ELSA 4th meeting, November 14, 2008

ELECTRICAL SAFETY PROVISIONS FOR VEHICLES IN USE

Figure 1: Measurement of V_b , V_1 , V_2

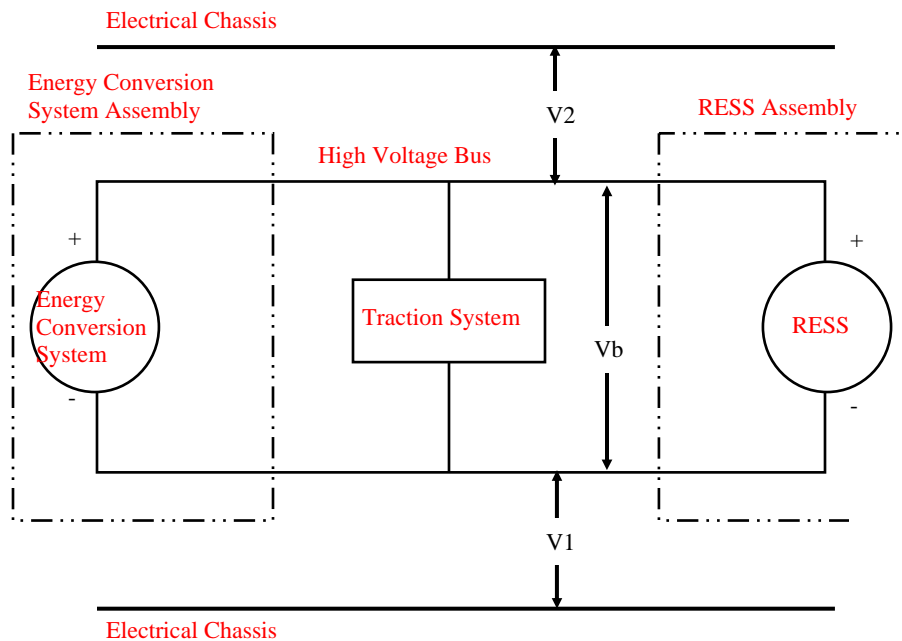
2-2-3-1 First step

The voltage is measured as shown in Figure 1 and the high voltage Bus voltage (V_b) is recorded. V_b shall be **must be** equal to or greater than the nominal operating voltage as specified by the vehicle manufacturer.

Figure 2: Measurement of V_1'

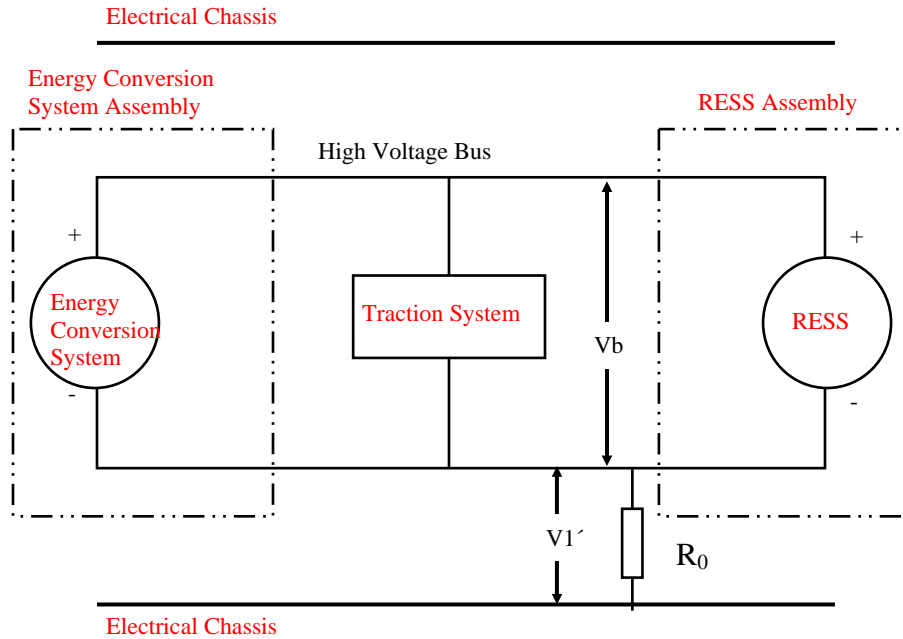
If V_1 is greater than or equal to V_2 , insert a standard known resistance (R_0) between the negative side of the high voltage bus and the electrical chassis. With R_0 installed, measure the voltage (V_1') between the negative side of the high voltage bus and the electrical chassis (see Figure 2).

Calculate the electrical isolation (R_i) according to the following formula:

$$R_i = R_0 * (V_b / V_1' - V_b / V_1) \quad \text{or} \quad R_i = R_0 * V_b * (1 / V_1' - 1 / V_1)$$

Figure 3: Measurement of V_2'

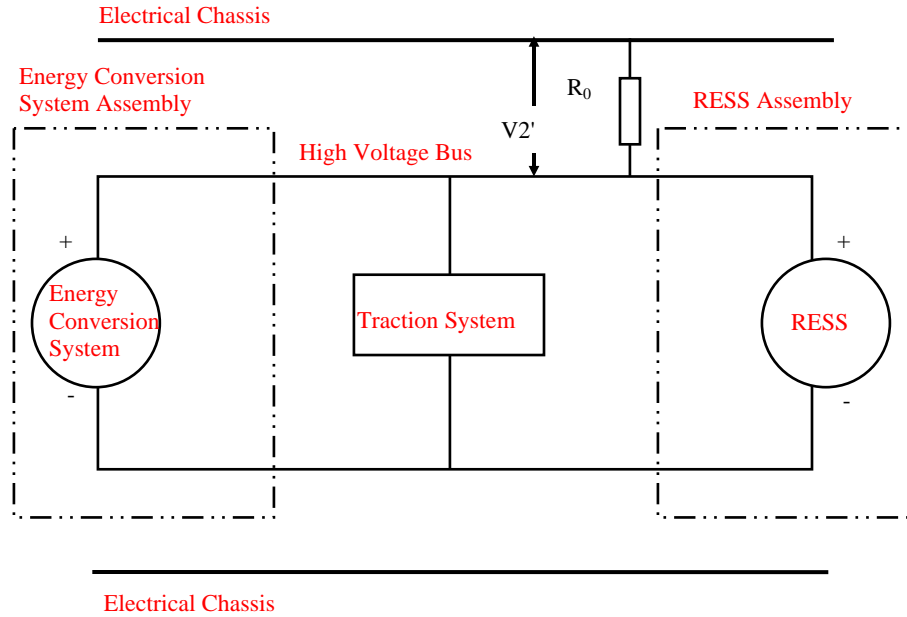
If V_2 is greater than V_1 , insert a standard known resistance (R_0) between the positive side of the high voltage bus and the electrical chassis. With R_0 installed, measure the voltage (V_2') between the positive side of the high voltage bus and the electrical chassis. (See Figure 3). Calculate the electrical isolation (R_i) according to the formula shown. Divide this electrical isolation value (in ohms) by the nominal operating voltage of the high voltage bus (in volts).

Calculate the electrical isolation (R_i) according to the following formula:

$$R_i = R_0 * (V_b / V_2' - V_b / V_2) \quad \text{or} \quad R_i = R_0 * V_b * (1 / V_2' - 1 / V_2)$$

Confirmation Method for Functions of On-board Isolation Resistance Monitoring System

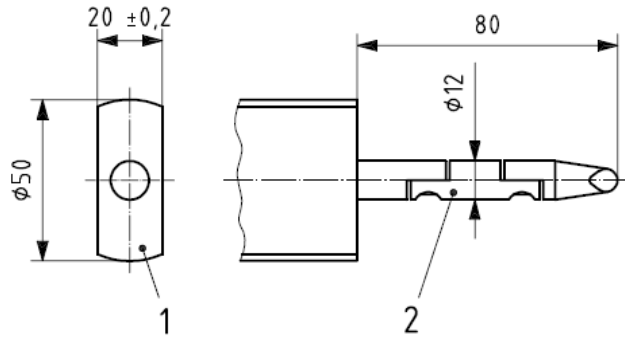
~~The on-board insulation resistance monitoring system shall be capable of monitoring the insulation resistance between the live parts and the electrical chassis and of giving a warning before it drops to 100 Ω/V for high voltage d.c. electric circuits or 500 Ω/V for high voltage a.c. electric circuits. Its function shall be confirmed by the method indicated in Paragraphs 2-3-1-1 through 2-3-1-2 or a method equivalent to it.~~

~~Warning of the driver shall be given when a resistor is inserted which makes the combined insulation resistance between the terminal being monitored and the electrical chassis 100 Ω/V for high voltage d.c. electric circuits or 500 Ω/V for high voltage a.c. electric circuits.~~

When a resistor is inserted which causes the isolation resistance between the terminal being monitored and the electrical chassis to drop below the minimum required isolation resistance value, the warning shall be activated.

Jointed test finger diameter 12; 80 length Dimensions in millimetres

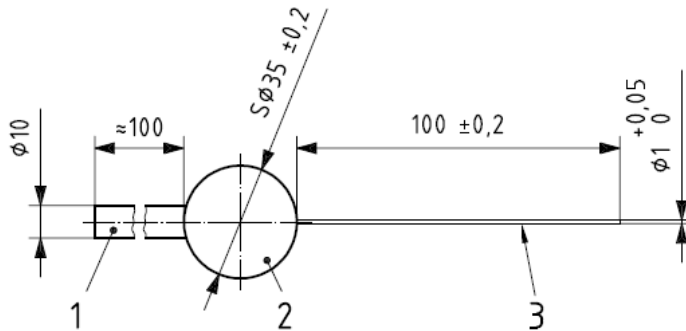
The jointed test finger may penetrate over its full length of 80 mm but shall not contact ~~be sufficiently distant from~~ the hazardous parts, even when its joints are bent at any optional angle (up to 90° from its axis) and are brought into any possible position. The stop face ($\phi 50$ mm · 20 mm) shall not pass through the opening.
The test force shall be $10 \text{ N} \pm 10 \%$.
